## Aquatic Development Strategy

## Volume 1: Technical Assessments & Probable Capitals Costs

## E-01

Site:	<b>Balmoral &amp; District Swimming Pool</b>	Date visited:	30 <sup>th</sup> June 2009 PRELIMINARY ISSUE
Project:	South Grampians Council – Aquatic Facility Development Strategy	Project No:	EJ-0763
Client:	Southern Grampians Shire Council	Representative:	Mr Craig Halley
Investigation undertaken by:	Sean Stone Mike Pettigrew	Company:	Etch Architectural Solutions David Powick & Associates
Copies to:	Steve Pallas	Company:	@Leisure
Weather Conditions:	Overcast conditions, high winds and frequent showers. Cold.		
Pages	<b>15 (including this page)</b>

- 12) Access to first aid room – not BCA compliant. Structural crack to landing. (narrow door to room)
- 13) First Aid room – appears more like a store room.

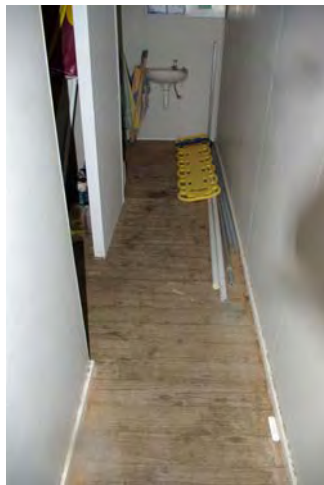
- 14) Passage way from entry door to first aid room – too narrow (max. 900mm width)
- 15) First Aid room – appears more like a store room.

- 17) Pool blankets appear in a reasonable condition
- 18) Timber access steps – reasonable condition – poor design and construction.
- 19) Plant room switch board appears in good condition.

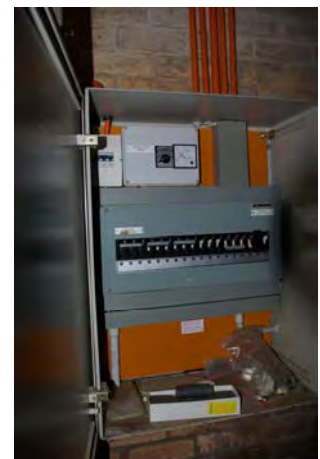
- 20) Store room – a dump.
- 21) View from 50m pool of plant room.

24) Stainless steel wall mounted basins to female change – too close and restricted.  
 25) Typical pan in change rooms

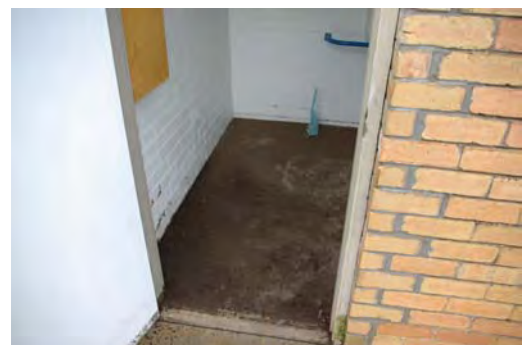
26) Typical urinal and wall mounted basins in male change rooms  
 27) Disabled toilet – subject to flooding. Note door frame corroded at base.
